RE: NHTSA No. 03V-517

RE: NHTSA Recall No. 03V-517

RSB03-160-001

SUBJECT: Hydraulic Fluid Leak

FIG. 3-1

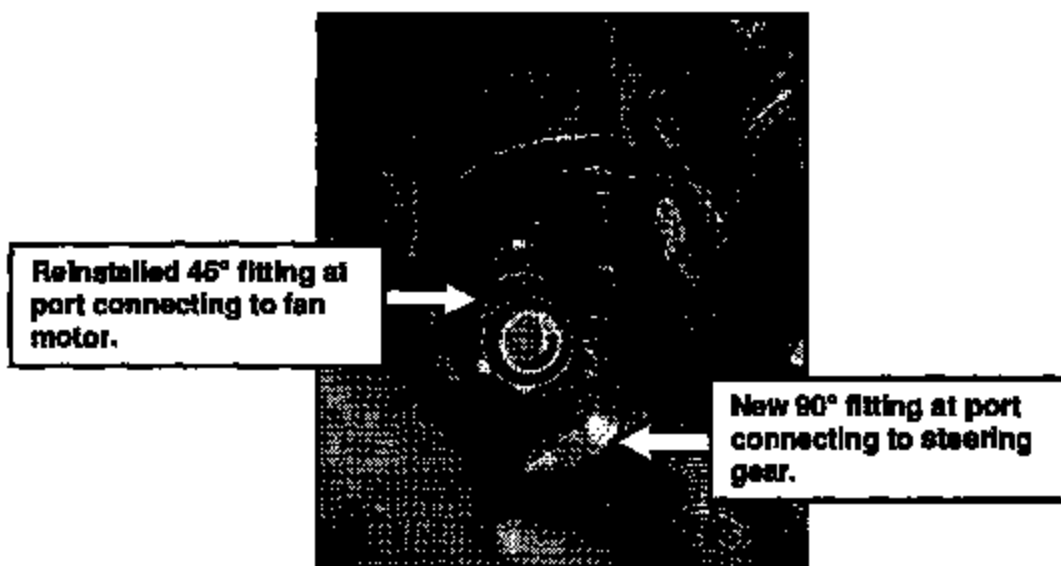
5. At the hydraulic pump, disconnect hoses to the steering gear and fan motor.
6. Remove the 45° fitting from the fan port and retain for reinstallation.
7. Remove the 45° fitting from the steering port and dispose of properly.
8. Refer to FIG. 3-1. Install the new 90° fitting into the steering port on the pump; positioning at 8:00 o'clock relative to the installed location of the pump. Torque nut to 27 +/- 2 lb. ft.

9. Reinstall the 45° fitting into the fan motor port on the pump; positioning at 1:00 o'clock relative to the installed location of the pump. Torque nut to 60 +/- 2.5 lb. ft.
10. Connect hose from steering gear to the new 90° fitting on the pump.

FIG. 4-1

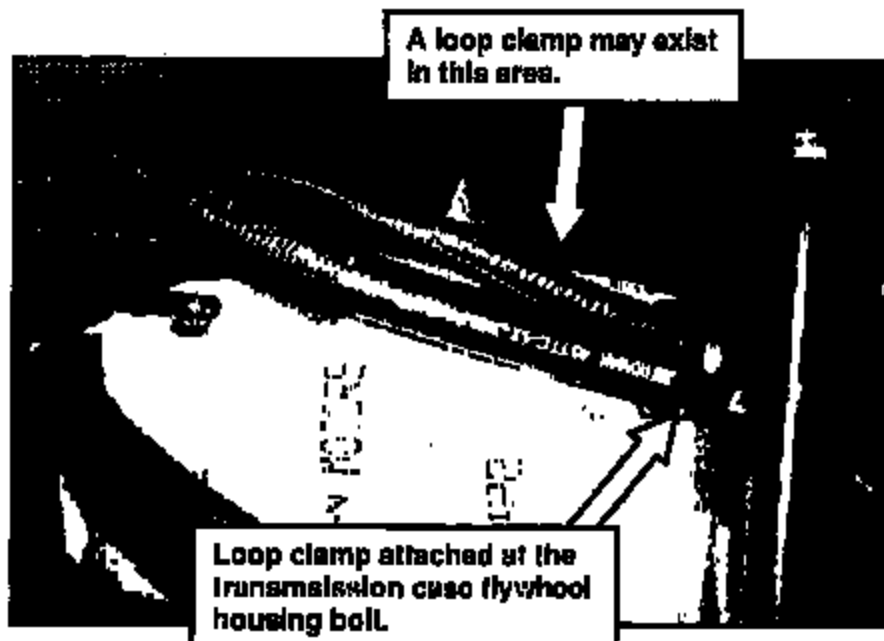
11. Before connecting the fan motor hose to the pump, it must be rerouted.

Route hose from the fan motor, over the flywheel housing (rather than under), and connect to the 45° fitting at the pump.

- 11a. Install a loop clamp to the transmission case/flywheel housing bolt closest to the dipstick tube as viewed from the top of the transmission. Refer to FIG. 4-1. If a clamp exists at a different transmission case/flywheel housing bolt, relocate it to accommodate the routing as shown. Torque bolt to 41 +/- 3 lb. ft.

FIG. 6-1

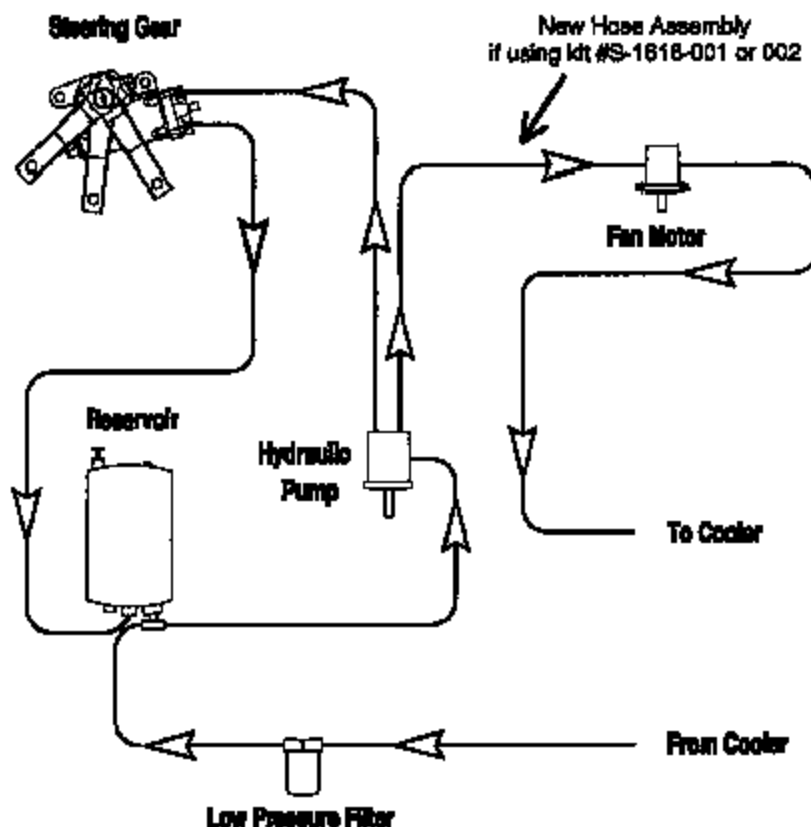
20. Connect hose routed from the steering gear, to the 90° fitting on the pump.
21. Install new hose assembly between the pump and fan motor, with 90° fitting connected at the pump.
